## SERVICE BULLETIN

**APPLICABILITY:** 2015-18MY Legacy and Outback **NUMBER:** 06-69-19R  
**SUBJECT:** Rear ABS Wheel Speed Sensor- Design Change **DATE:** 02/07/19  
**REVISED:** 02/20/19

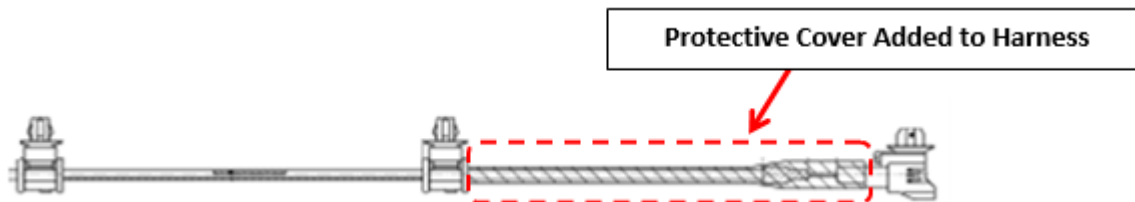
This bulletin announces a design change made to the rear ABS wheel speed sensor on the models listed above. The change involves the addition of an additional shielding cover to protect the harness from damage caused by road debris.
